LAND USE APPLICATION SUMMARY

Property Location: 2900 Pleasant Avenue and a portion of 312 West Lake Street
Project Name: Rana Village
Prepared By: Aaron Hanauer, Senior City Planner, (612) 673-2494
Applicant: Scott Nelson, DJR Architects
Project Contact: Scott Nelson
Request: To allow for a new multiple-family residential development.
Required Applications:

MINNEAPOLIS
 Department of Public Works
 DRAWN: JTC DATE: 9/18/07
 APPROVED: GAB DATE: 9/18/07
 STANDARD PLATE NO. ROAD-2003

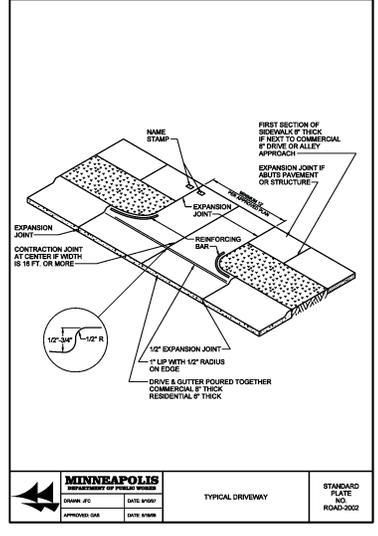
- The Minneapolis Standard Plate ROAD-2003 provided on Sheet C5.0 has been updated and shall be replaced with ROAD-2003-R1. Please refer to the following:
http://www.minneapolismn.gov/publicworks/plates/public-works_road .
- The Landscaping plans indicate portions of the existing alley right-of-way being landscaped with turf, trees, and other plantings, which will not be allowed. The Public right-of-way established for the existing alley includes a "hammer head" turn around extension and a corner extension for vehicle turning radius at the 90 degree bend; the full alley right-of-way must remain as a Public alley, and shall remain paved (or re-paved if damaged during construction).
